Loddon Garden Village - North

DESIGN RESPONSE

Prepared by:	Chris Shaw
Authorised by:	Leigh Abley
Date:	08 July 2025
Document Reference:	A392 – R065 LGV North RSA 2 Designers Response

Road Safety Audit – Loddon Garden Village North

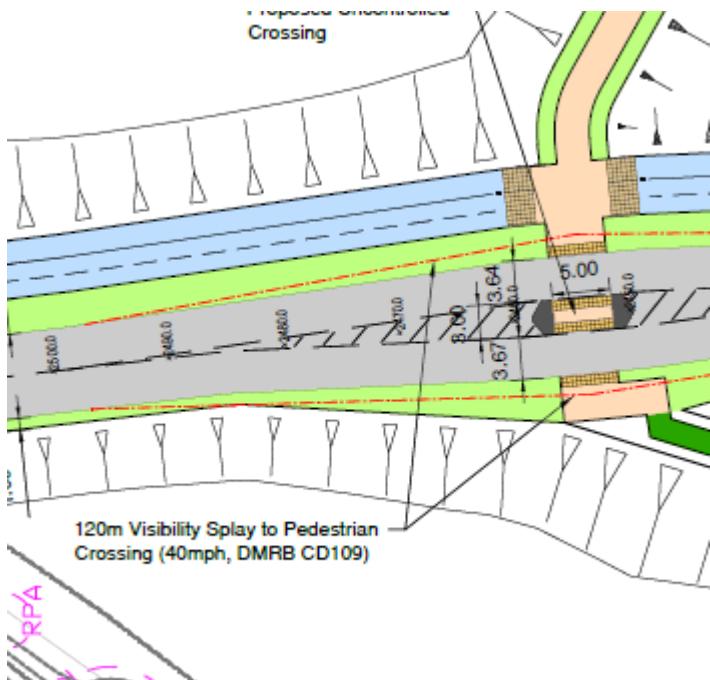
The visibility distances quoted on drawing 0108A are 120 metres, however from the chainage figures shown on the drawing the splays appear to be no more than 45 metres

Recommendation – Ensure the full 120 metres sightlines can be achieved

2.16.4 Noted, drawing error, speeds are to be 30mph therefore 43m sightlines are required (MfS). Drawing to be amended.
